Local Grant Identification for EPOC TDD (baseline proposal amendment)

Andrea Garavaglia and Patrick Stupar
(Qualcomm)

Gate processing in CLT for local (TDD) grant

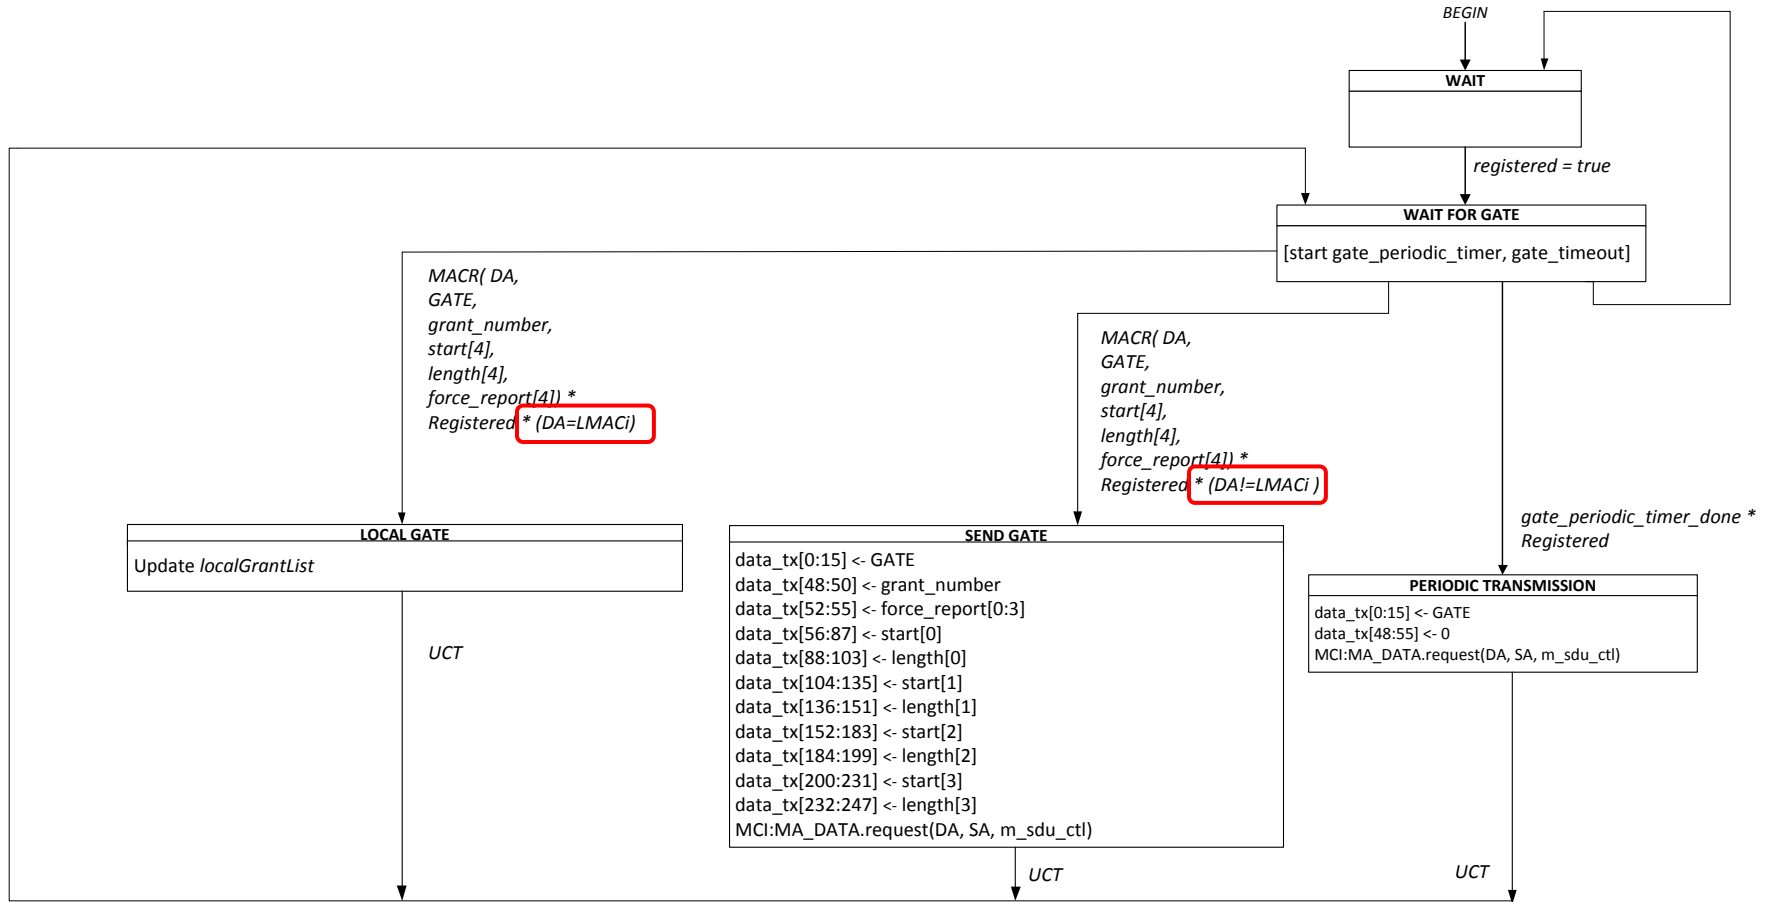
In the current design, the DA is used to identify a Local Grant from a CNU Grant (see red boxes above).

Comment: the Destination Address (DA) for non-discovery GATE in the *MA_CONTROL.request* primitive is defined in IEEE 802.3 Clause 77.3.3.5 as “Multicast MAC Control address as defined in Annex 31B”.

Solution #1: definition of a new MAC control address

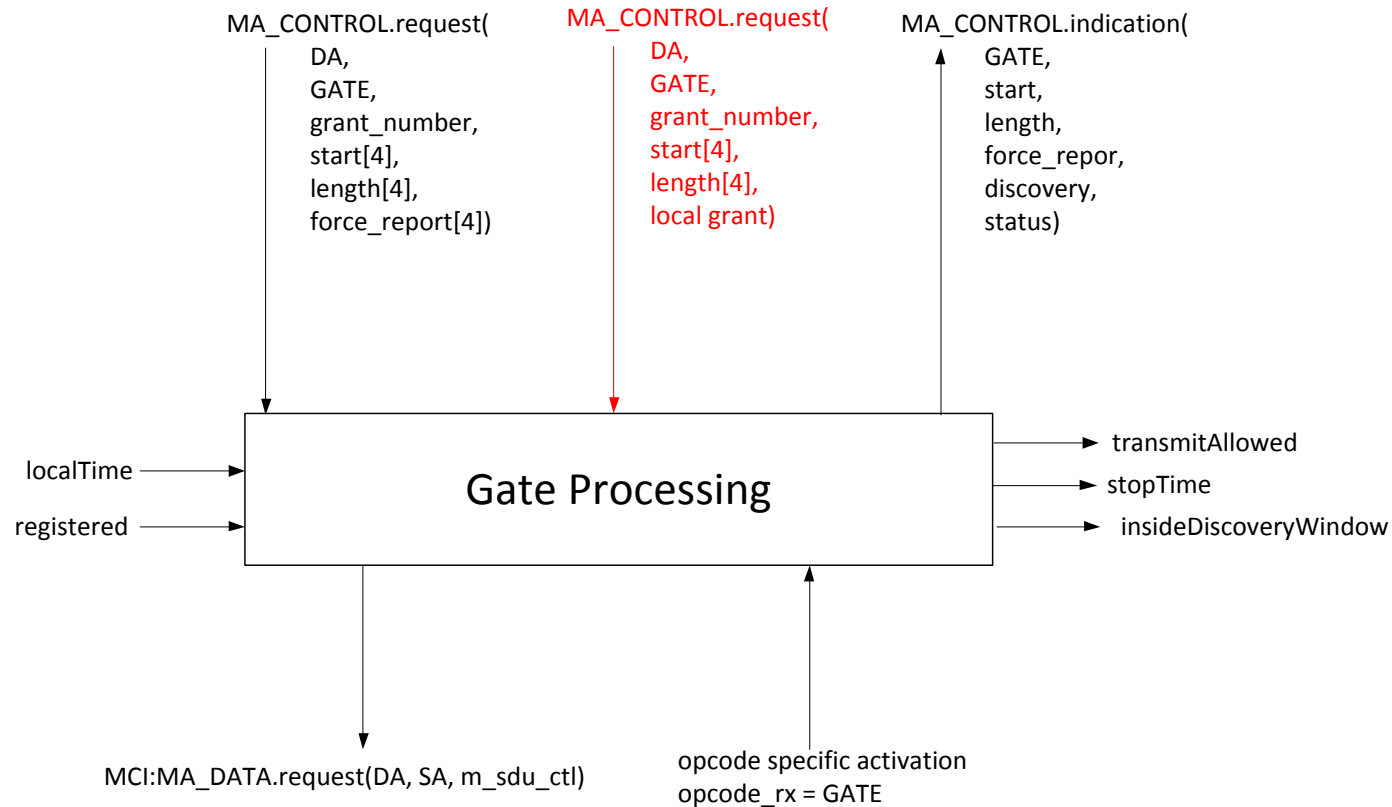
Definition of new MAC control multicast address (e.g. 01-80-C2-00-00-02) and extension of the *MA_CONTROL.request* primitive

MA_CONTROL.request (DA, GATE, grant_number, start[4], length[4], force_report[4]). This request primitive is used by the MAC Control client at the CLT to issue the GATE message to an CNU and to issue local grants for downstream transmission in TDD mode.

- DA: Multicast MAC Control address as defined in Annex 31B (if the primitive is used to issue the GATE message) or Multicast MAC Control address as defined in XX (if the primitive is used to issue the local grant GATE)
- GATE: Opcode for GATE MPCPDU as defined in Table 31A–1.
- grant_number: Number of grants issued with this GATE message. The number of grants ranges from 0 to 4.
- start[4]: Start times of the individual grants. Only the first grant_number elements of the array are used.
- length[4]: Lengths of the individual grants. Only the first grant_number elements of the array are used.
- force_report[4]: Flags indicating whether a REPORT message should be generated in the corresponding grant. Only the first grant_number elements of the array are used.

Solution #2: Definition of a local grant primitive

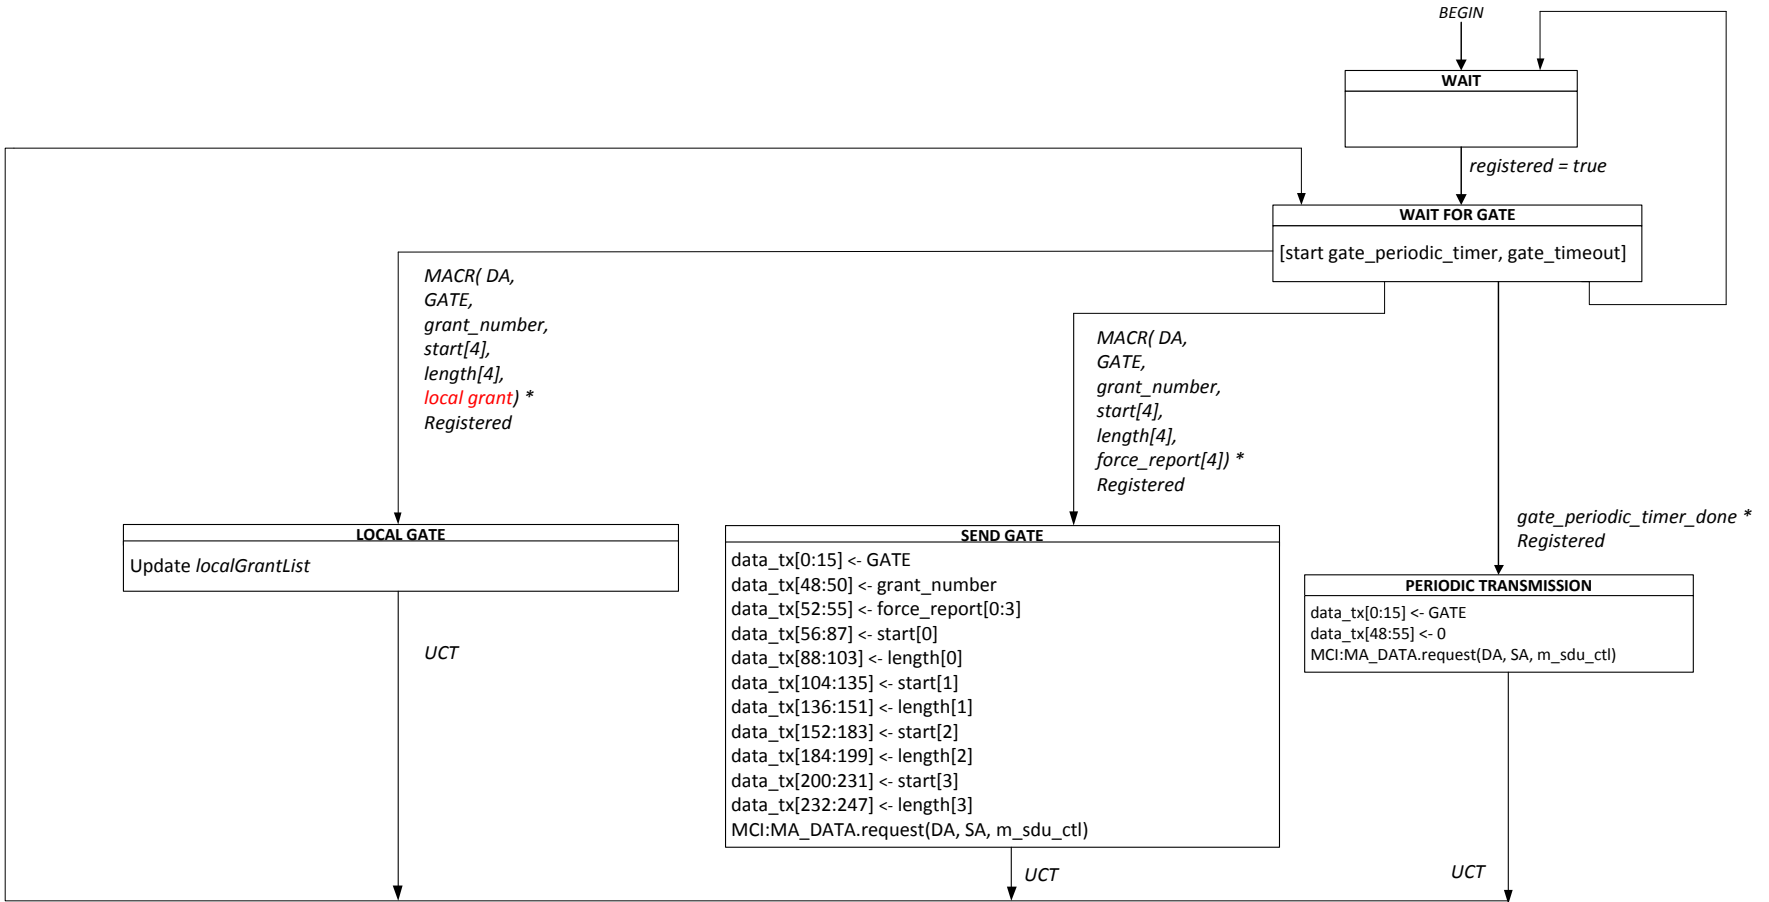
Two different service primitives entries in Gate processing block (one for local grant GATE and one for GATE messages transmission)

GATE primitive for local grant is defined in a similar way as GATE primitive for discovery

Note: the state machine for local grant *MA_CONTROL.request* request primitive may be defined separately

Solution #3: Extension of the existing primitive

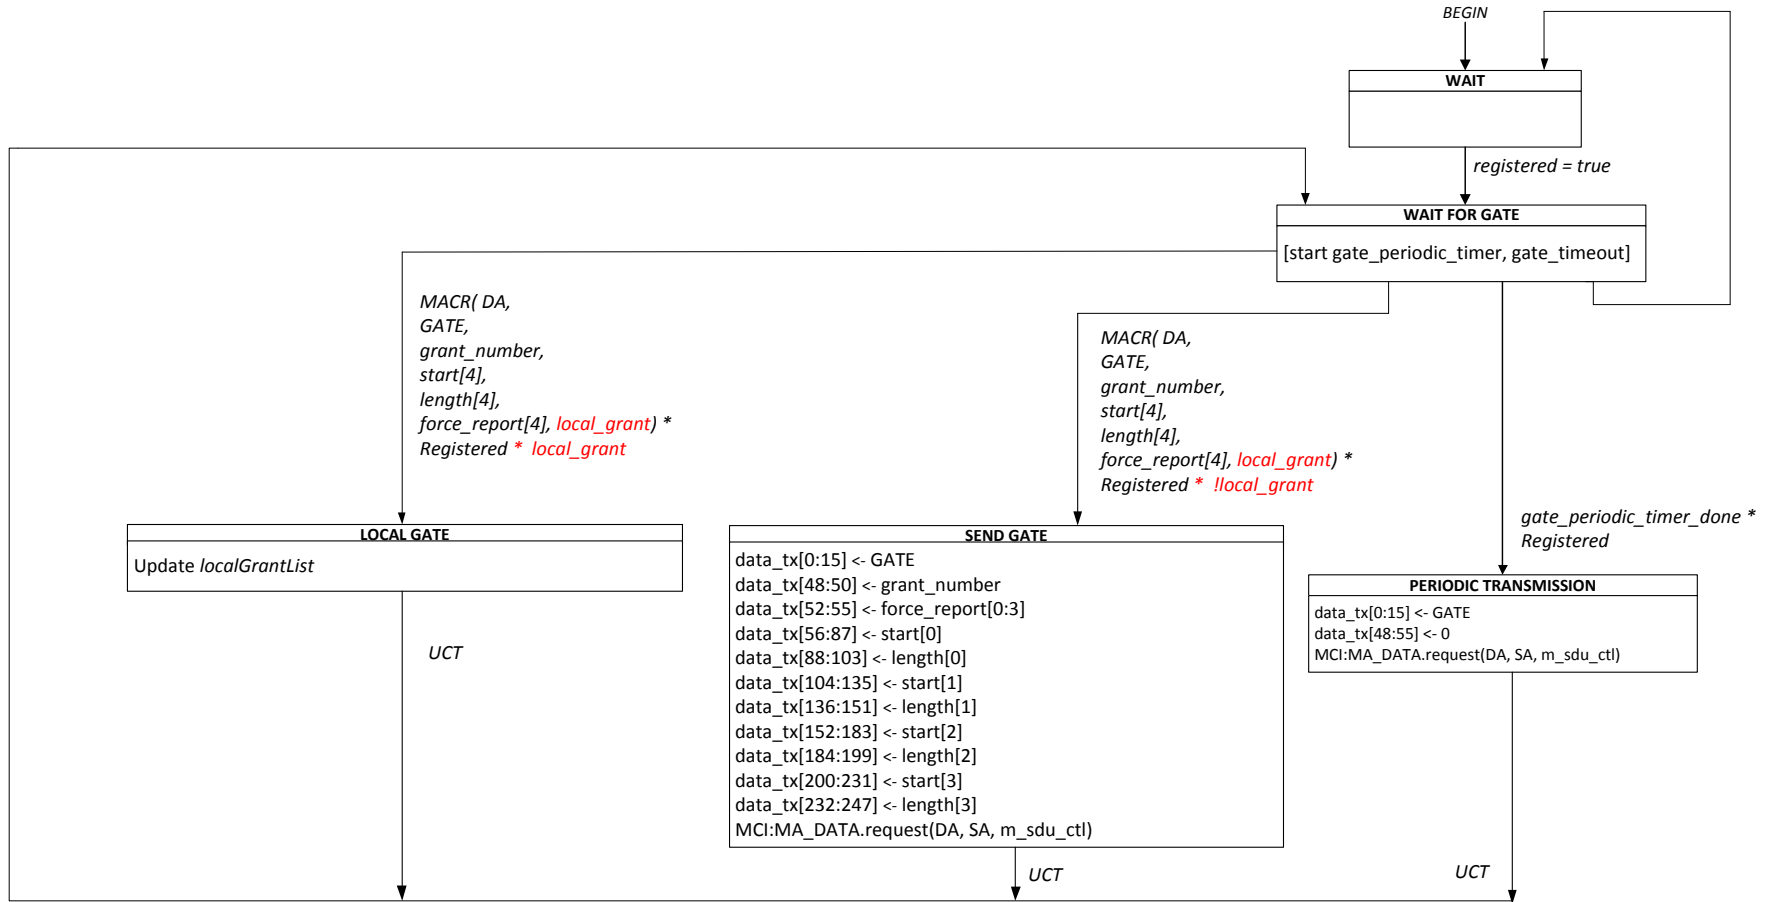
Just one request primitive entry in GATE processing block, applicable to both local and remote grants. The new boolean variable *local_grant* is used to distinguish the local grant from other grants.

Existing MACR request primitive is extended by addition of a new optional boolean variable named *local_grant*, with default value = FALSE unless explicitly set.

MA_CONTROL.request(DA, GATE , grant_number, start[4], length[4], force_report[4], **local_grant**). This request primitive is used by the MAC Control client at the CLT to issue local grants for downstream transmission in TDD mode.

- DA: Multicast MAC Control address as defined in Annex 31B
- GATE: Opcode for GATE MPCPDU as defined in Table 31A–1.
- grant_number: Number of grants issued with this GATE message. The number of grants ranges from 0 to 4.
- start[4]: Start times of the individual grants. Only the first grant_number elements of the array are used.
- length[4]: Lengths of the individual grants. Only the first grant_number elements of the array are used.
- force_report[4]: Flags indicating whether a REPORT message should be generated in the corresponding grant. Only the first grant_number elements of the array are used.
- **local_grant**: **Boolean variable specifying whether the given grant is a local grant (when set to TRUE) or not (when set to FALSE). Default value is FALSE.**
